**ZOO INTERCHANGE
REDUCED IMPACTS
ALTERNATIVE
MILWAUKEE COUNTY:
ROAD SAFETY AUDIT**

ROAD SAFETY AUDIT

FINAL REPORT

December, 2011

Non-Motorized Road Users Crossing at Free-Flow Loop Ramps

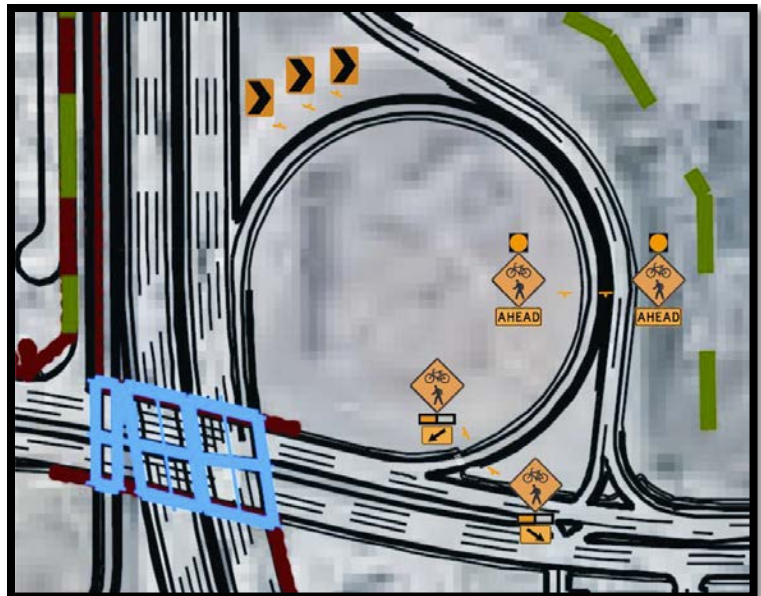
The free-flow loop ramps at both Wisconsin Avenue and North Avenue create a safety issue for non-motorized road users at these locations. Free-flow ramps are designed to reduce delay and increase mobility among motorists. Free flow loop ramps pose a potential risk to non-motorized road users as a result of the lack of traffic control devices available at this type of junction. The extreme speed differentials between pedestrians and motor vehicles are likely to result in serious injuries. Additionally, in many cases, sight distance is also limited as a result of the radius of curvature of the loop ramp.

Alert motorists to the potential for non-motorized road users to be crossing near the ramp terminal by installing warning signs. Consider installing pedestrian crossing warning signs with attached flashing beacons.

1a Agree this has been incorporated into our design. It now includes a free flow right turn lane add and has 45 degree islands.

Non-Motorized Road Users Crossing Channelized Right-turn Lanes

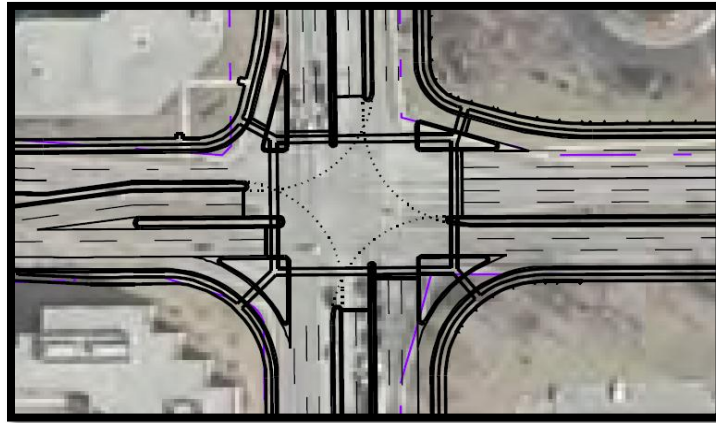
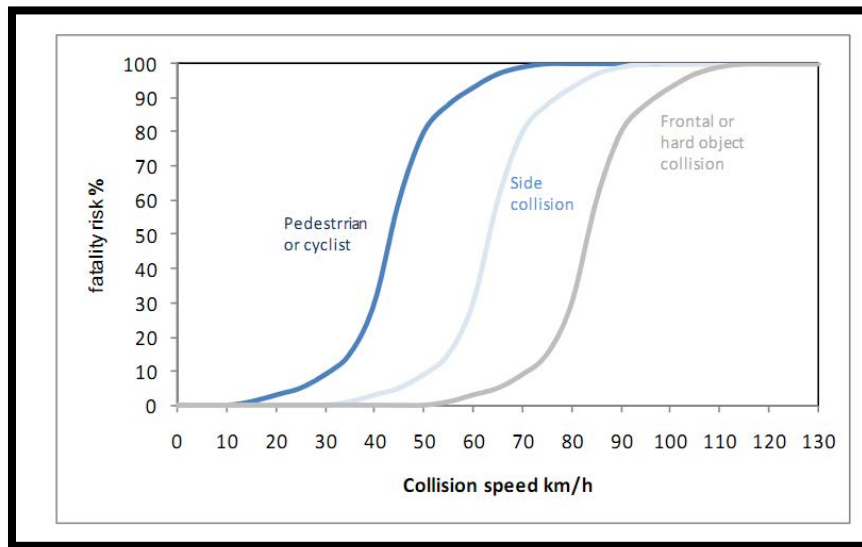
Channelized right-turn lanes, such as those pictured below, can be found throughout the study area. Channelized right-turn lanes decrease delay for motorists by creating a yield controlled intersection allowing for motorists to maintain both speed and momentum when gaps in oncoming traffic present themselves.

This ease-of-use enhancement for motorists creates a potential safety issue for non-motorized road users. Pedestrians and bicyclists attempting to cross the channelized right-turn may not be in many drivers sight-triangle. Additionally, pedestrians may not have the ability to move quickly enough to clear the crosswalk given the higher speeds of vehicles utilizing this lane. Elderly drivers, or those with limited mobility, may have increased difficulty maneuvering their bodies to check for oncoming traffic over their shoulders.

Consider converting all of the 45°/45°/90°-style (see; southwest and southeast islands as shown above) channelization islands to 30°/60°/90°-style (see; northwest and northeast islands as shown above) channelization islands. This adjustment will, while maintaining the efficient yield control, require that drivers reduce their speeds by a larger margin as a result of the change in geometry of the intersection. Additionally, pedestrians and bicyclists will be in a position more visible to motorists.

1b Agree this will be incorporated in preliminary design.

Bike Lanes on STH-100

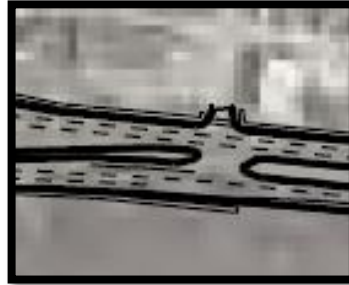
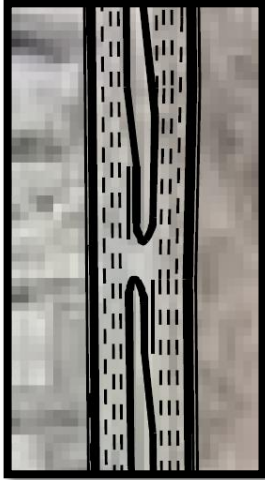
The Reduced Impacts Alternative design proposes a bicycle lane into the plan for STH-100 between IH-94 and Watertown Plank Road. Given the projected traffic volumes and the current 45 M.P.H. speed limit on this roadway, the potential for serious bicycle/motorized vehicle interaction to occur is high.

Consider revising the Reduced Impacts Alternative design to remove the proposed bicycle lanes from STH-100. An alternative may be to create a shared-use path where-in both bicyclists and pedestrians can share a single space set back from the roadway. A shared use path is a safer alternative to an in-road lane as the potential speed differentials between a bicyclist and a pedestrian are likely to result in less-severe injuries. Removing bicyclists from the shoulder will significantly reduce the likelihood of serious bicycle/motor-vehicle interactions occurring.

1c Trans 75 requires inclusion of ped/bike accommodations. The Zoo Interchange Project Team was required to include bike lanes by the Statewide Bicycle & Pedestrian Coordinator.

The FDM states that WisDOT and federal policy, state statutes and administrative codes require include bicycle accommodations on all new construction and reconstruction highway projects. The [Wisconsin's Bicycle Facility Design Handbook](#) states that the WisDOT recognizes the importance of the bicycle as a legitimate mode of transportation and for some people the bicycle is their main or only mode to transportation (page 1-1). State statute considers bicycles as vehicles and are allowed and expected to be on STH 100.

In the 2011 traffic counts it showed that in a 13 hour period at Watertown Plank Rd. and STH 100, there were a total of 77 bicyclists going through the intersection. STH 100 is an arterial street where major businesses and institutions are often located and are destination points for people, including bicyclists. "Common improvements recommended for arterial streets include: bicycle lanes, wide outside lanes, or shoulders (page 2-5). The Handbook states that bicycle lanes are the preferred bicycle facility on higher volume urban and suburban roadways (i.e. Arterial streets), (page 3-1) Among the benefits of bicycle lanes are providing adequate width for bicycles which is imperative so that the motorist may pass a bicyclist and stay in the travel lane.

Suggesting that bicyclist use a shared use path through this corridor does not follow design standards. The Handbook points out that "these paths are a complementary system of off-road transportation routes for bicycles and others. They should not substitute for on-road bicycle facilities, but rather supplement a system of on-road bike lanes, wide outside lanes and paved shoulders" (page 4-1) A 2006 bicycle /motor vehicle crash study showed that 29% of urban crashes reported were sidepath/sidewalk crashes.

Figure 5-1 STH-100 at Wisconsin Avenue

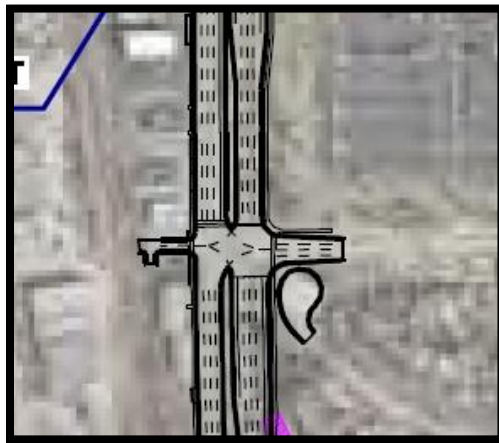
Negatively offset left-turn lanes are present in the Reduced Impacts Alternative Design at the intersection of STH-100 and Wisconsin Avenue as well as at the intersection of Bluemound Road with Glenview. Negatively offset left-turn lanes increase the likelihood of serious angle-type collisions occurring at intersections. The negative offset of opposing left-turn lanes greatly reduces intersection sight distance and may lead to drivers making poor choices in traffic gaps.

Consider reconfiguring these negatively offset left-turn lanes to reflect the safer alternative of positively offset left turn lanes. Positively offset left-turn lanes increase intersection sight distance and will likely reduce the risk of serious angle-type crashes occurring. Protected signal phasing for u-turn movements at the intersection may also be a feasible improvement.

3b These intersections will have protected left turn signal phasing.

Short Left-Turn Lane, IH-894/USH-45 and Greenfield

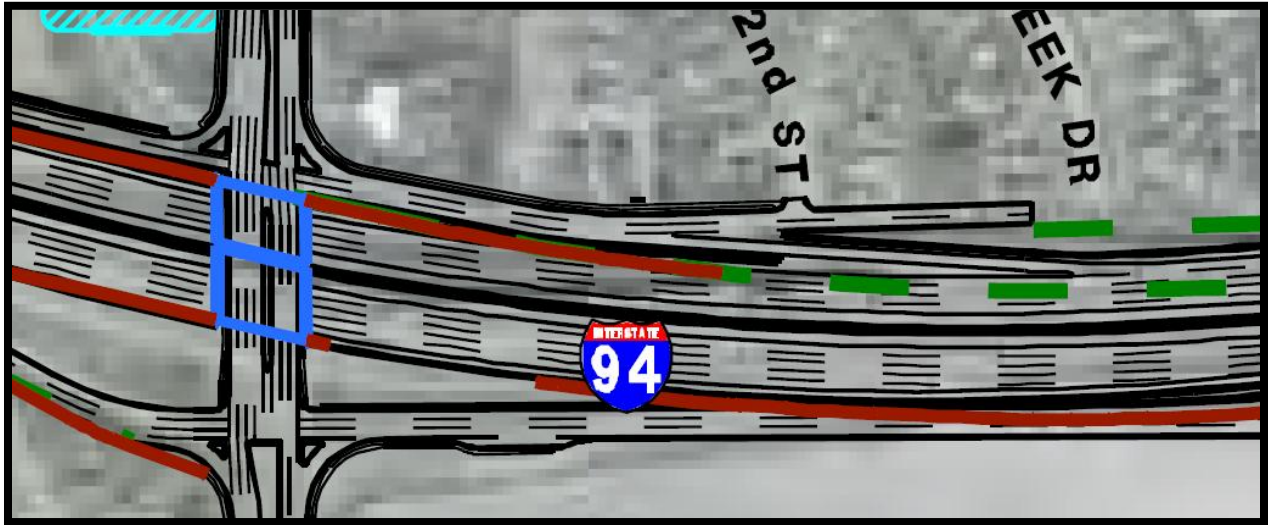
The storage provided for left-turn movements from Greenfield Road to IH-894/USH-45 may be inconsistent with the projected demand volumes for the year 2035. The current design will likely lead to the presence of queues, weaving maneuvers, increased driver frustration and red-light running.

Lengthen the left turn lane to accommodate for more vehicles. This increased storage will reduce the potential for rear-end collisions, and sideswipe crashes by vehicles in neighboring lanes.

7c They have been lengthened in preliminary design.

IH-94 at 84th Street, Weave Section

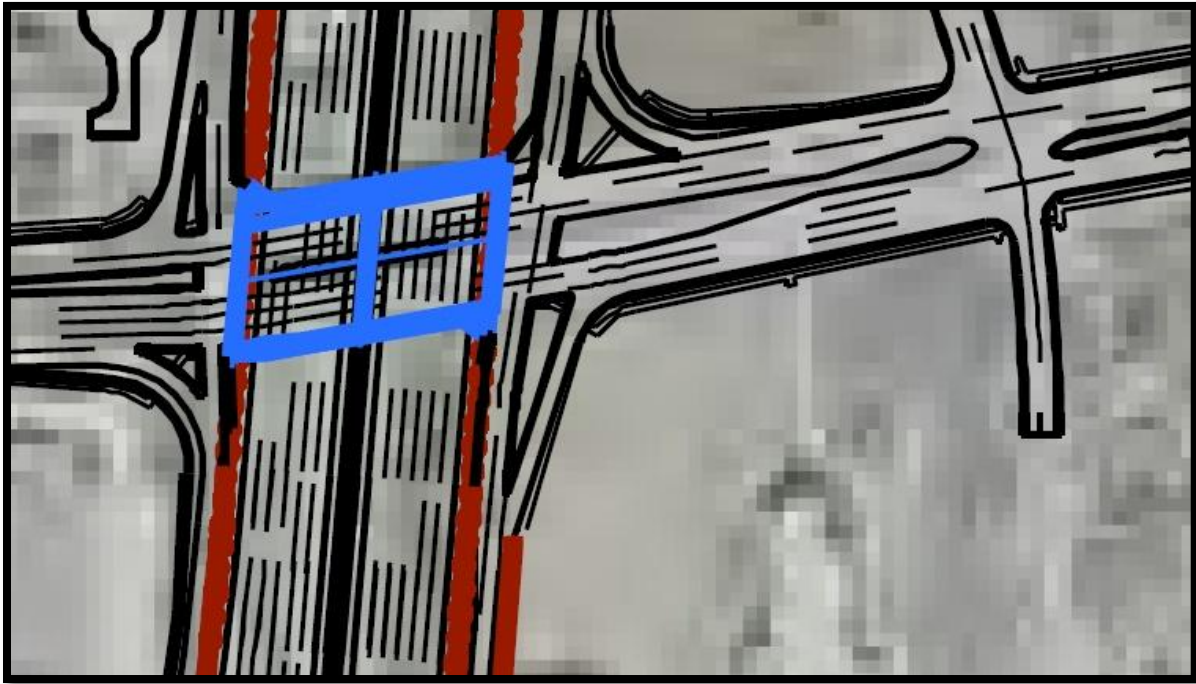
A weave section exists in the Reduced Impacts Alternative Design at the exit-ramp from IH-94 to 84th Street. Motorists intending to head north on 84th Street from westbound IH-94 must merge with traffic from the frontage road and cross two lanes in order to make a right turn.

Review the projected traffic volumes for the frontage road at this location to determine if the provided capacity is required. If the volumes do not support the need for two lanes on the frontage road, consider reducing the frontage road to a single lane. If the projected traffic volumes warrant two lanes on the frontage road, consider moving the exit-ramp to the east to increase the total distance available to drivers to make merging maneuvers.

7d We can discuss with the City of Milwaukee but O'Conner is heavily used during state fair. We will investigate further.

Option Lane Exit Signing

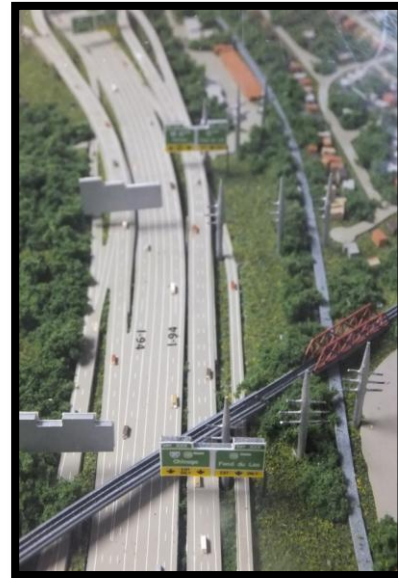
The proposed signing for northbound USH-45 at Watertown Plank Road may not meet MUTCD standards for signing.

Consider verifying that the proposed signing meets current MUTCD standards for guide signs. A standard guide sign for this location may be configured similarly to the sign found below.

8a The guide sign plan has been updated and currently meets MUTCD standards.
